TECHNICAL SERVICE BULLETIN

Soft Top Wear Above B-Pillar

22-2274
17 October 2022

Ford 2021-2022 Bronco

Figure 1

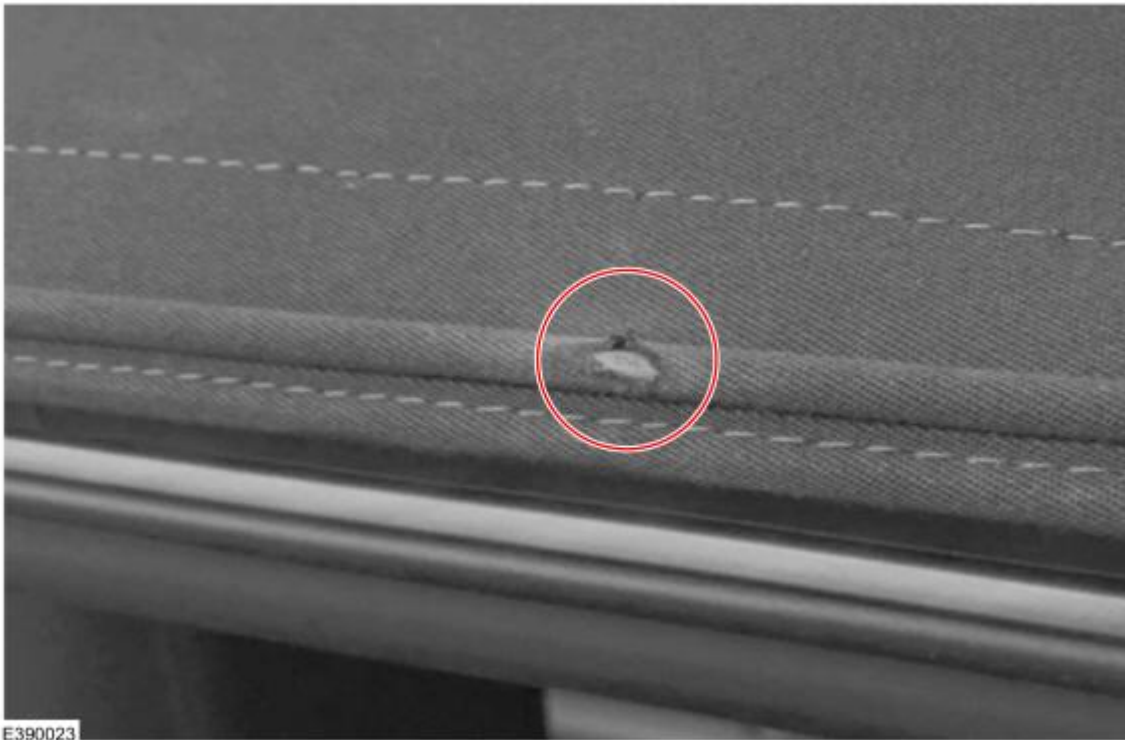
Issue: Some 2021-2022 Bronco vehicles equipped with a soft top may exhibit exterior wear on the sides of the top above the B-pillar. This may be due to contact and rubbing between the soft top frame and fabric. To correct the condition, follow the Service Procedure to replace both right and left deflectors attached to the soft top frame and soft top cover.

1. Does the soft top exhibit wear above the B-pillar similar to Figure 1?

(1). Yes - proceed to Step 2. Updated deflectors will be installed on both sides of the soft top frame assembly to prevent wear.

Figure 3

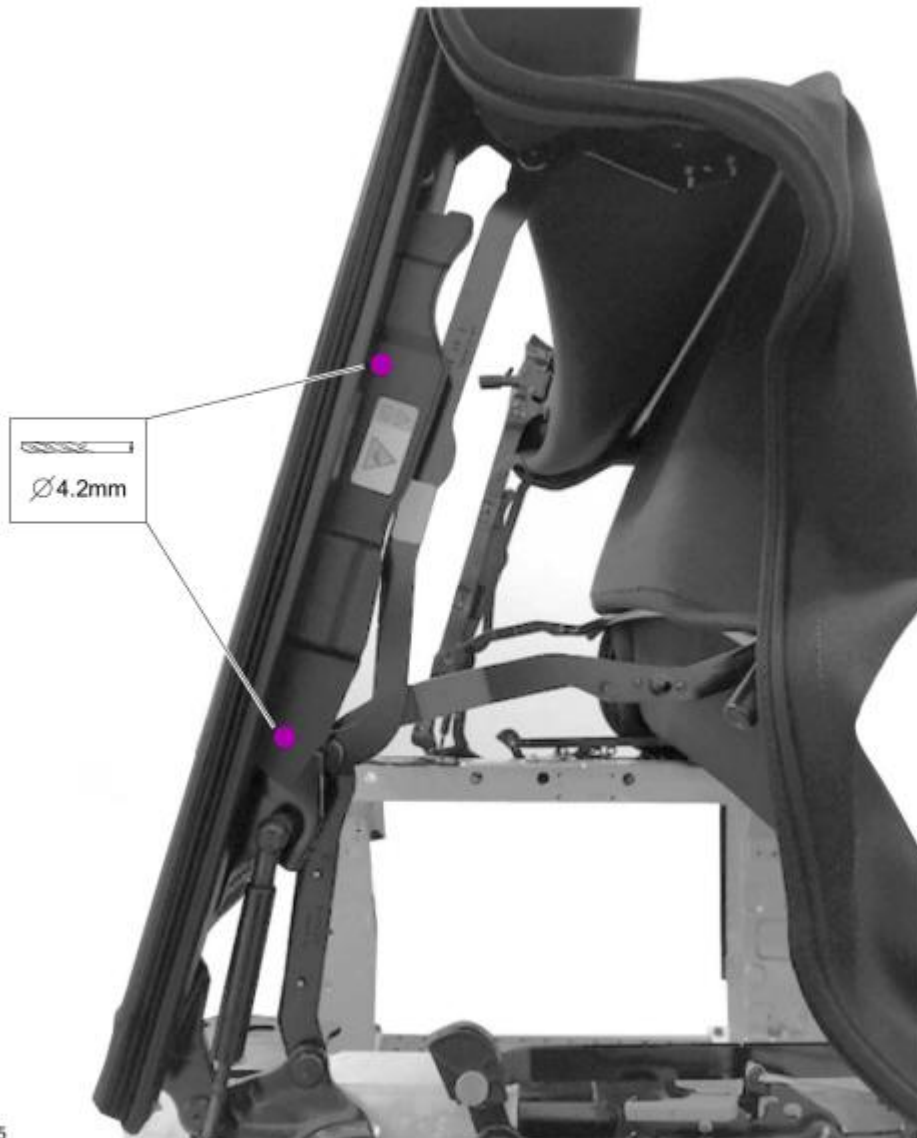
CAUTION: Do not drill through the linkage assembly. Only the head of the rivet should be drilled. Drilling through the linkage enlarges the hole where a new rivet will not fit to secure the linkage.

4. Locate each deflector on the right and left side of the frame assembly and drill out 2 rivets per deflector using a 4.2 mm (11/64 in) drill bit. (Figure 3)

5. Attach an updated deflector on each side of the frame using rivets, securing the new deflector to the frame assembly starting from the front moving to the rear.
6. Remove and replace the soft top cover. Refer to the Workshop Manual (WSM) Section 501-18A Soft Top > Removal and Installation > Soft Top Material.
